CITY OF ALBUQUERQUE

Re: Townhouses for Greg Lobberegt
2400 Marie Park NE
Traffic Circulation Layout
Architect's Stamp 09-01-16 (H22D026)

Based upon the information provided in your submittal received 09-01-16, the above referenced plan cannot be approved for Building Permit until the following comments are addressed:

1 TRAFFIC CONTROL LAYOUT
Scale: 1" = 20'-0"

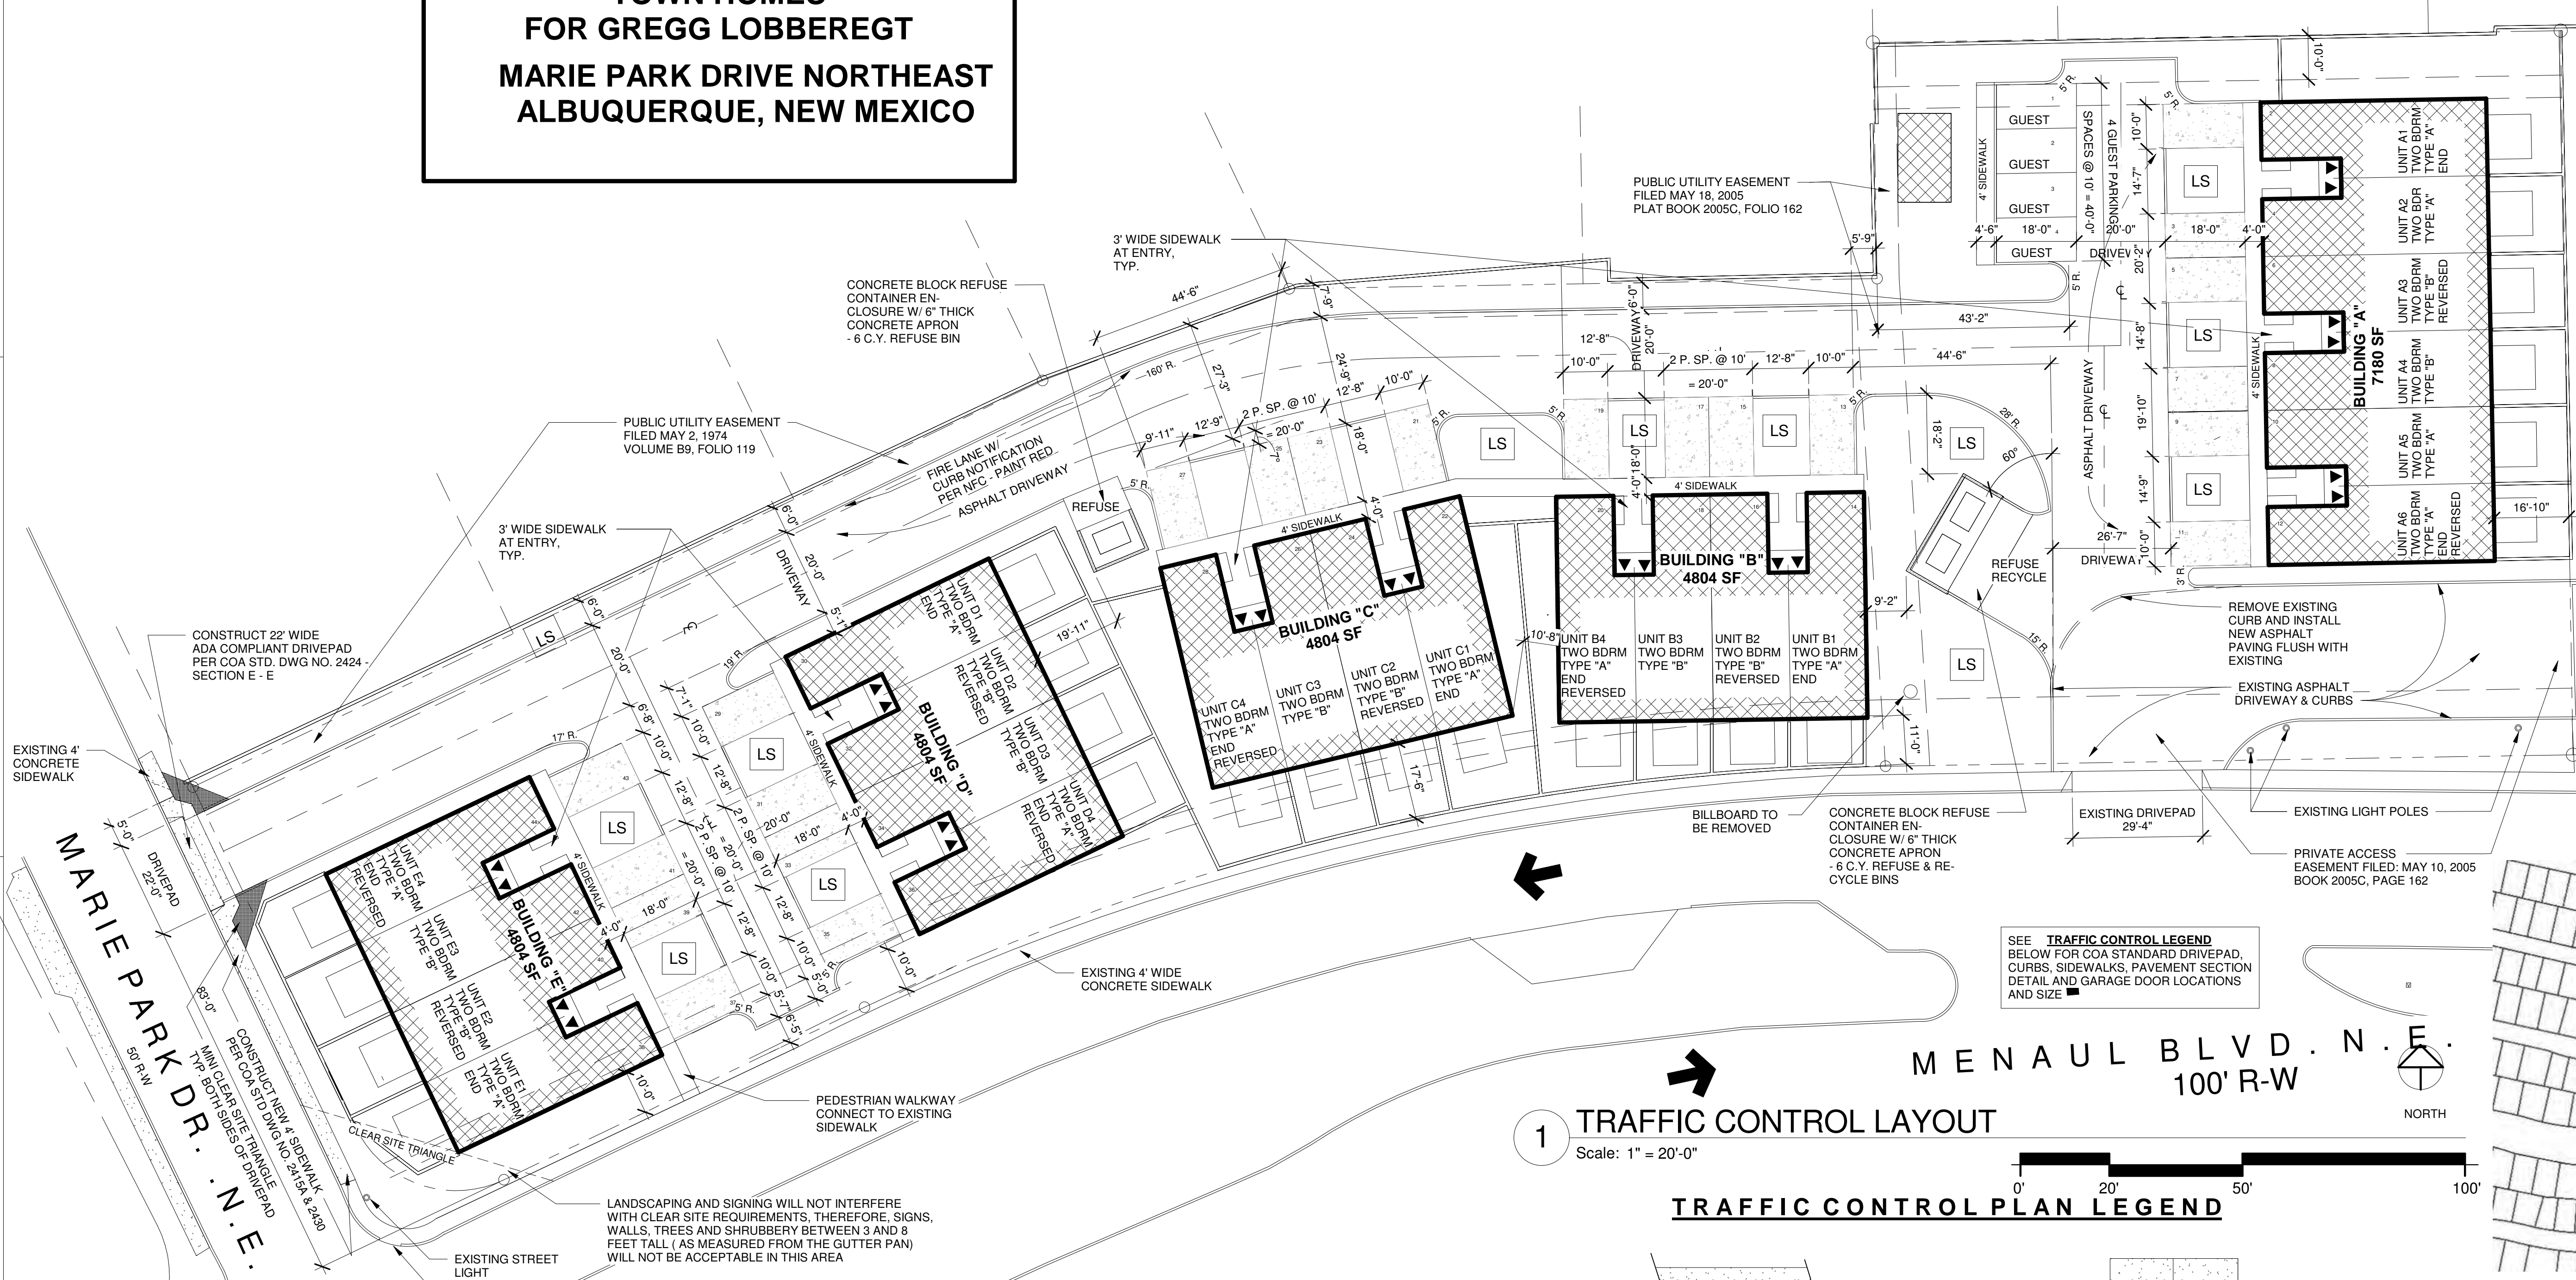
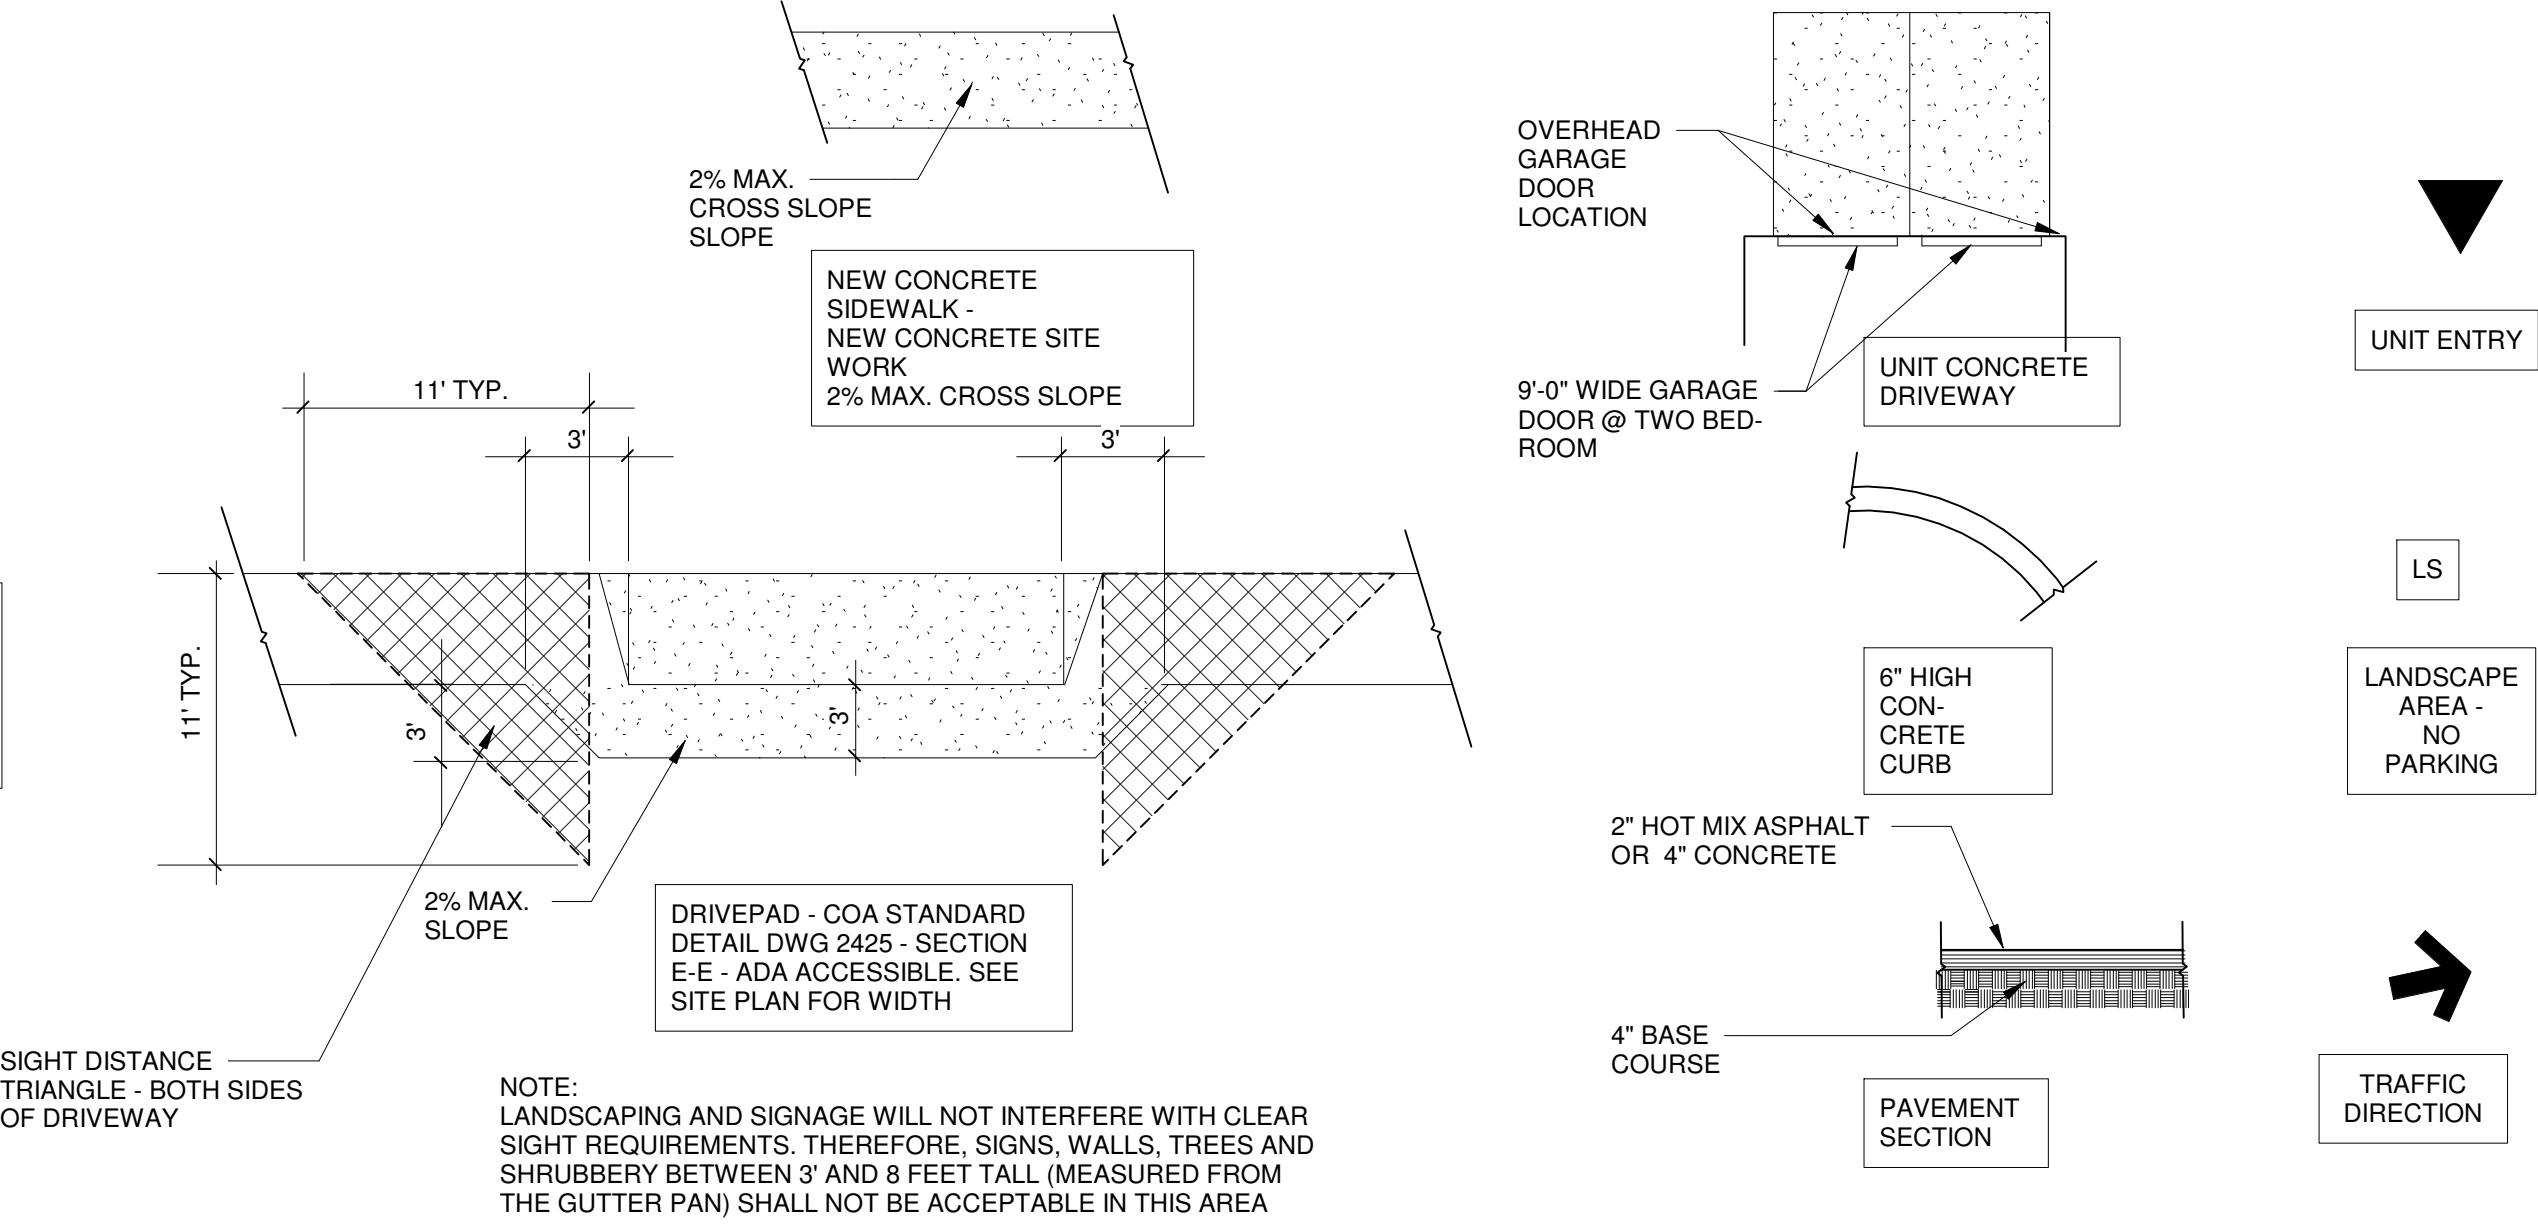
1. List the number of parking spaces required by the zoning code as well as the proposed number of parking spaces including bicycle and motorcycle parking.

2. Please list the width and length for all existing and proposed parking spaces. Some dimensions are not shown.
3. The handicap accessible spaces must be a minimum of 8.5 ft. in width.

4. The handicap accessible spaces must include an access aisle. Van accessible aisles should be 8ft wide; all others should be 5ft wide.
5. The ADA accessible parking sign must have the required language per 66-7-352.4C NMSA 1978 **"Violators Are Subject to a Fine and/or Towing."** Please call out detail and location of HC signs.

6. The ADA access aisles shall have the words **"NO PARKING"** in capital letters, each of which shall be at least one foot high and at least two inches wide, placed at the rear of the parking space so as to be close to where an adjacent vehicle's rear tire would be placed. (66-1-4.1.B NMSA 1978)

7. Show the drive aisle width between buildings "E" and "D".
8. DPM chapter 23, Figure 23.7.1 does not apply to major circulation aisles.
9. Drive aisle width less than 24' must be one-way vehicular paths that require pavement directional signage and a posted **"Do Not Enter"** sign at the point of egress. Please show detail and location of posted signs.

10. List radii for the Solid waste refuse between buildings "D" and "C". Radius for delivery trucks, fire trucks, etc. is 25 ft. or larger.
11. A 5 ft. keyway is required for dead-end parking aisles.

12. Per the zoning code, a 6 ft. wide ADA accessible pedestrian pathway is required from the public sidewalk to the building entrances. Please clearly show this pathway and provide details.

13. Per DPM, a 6 ft. wide ADA accessible pedestrian pathway is required from the HC parking stall access aisles to the building entrances. Please clearly show this pathway and provide details.

14. Service vehicle and/or refuse vehicle maneuvering must be contained on-site; provide a copy of refuse approval.
15. It is not apparent what type of pavement surface is being proposed. A hard driving surface will be required as part of this proposed project for parking area and drive aisles.

16. Please specify the City Standard Drawing Number when applicable.
17. Please include a copy of your shared access agreement with the adjacent property owner.

18. See Chapter 23, Section 6 of the City of Albuquerque *Development Process Manual*, for appropriate drive pad widths.
19. Add a note stating "All broken or cracked sidewalk must be replaced with sidewalk and curb & gutter." A build note must be provided referring to the appropriate City Standard drawing.
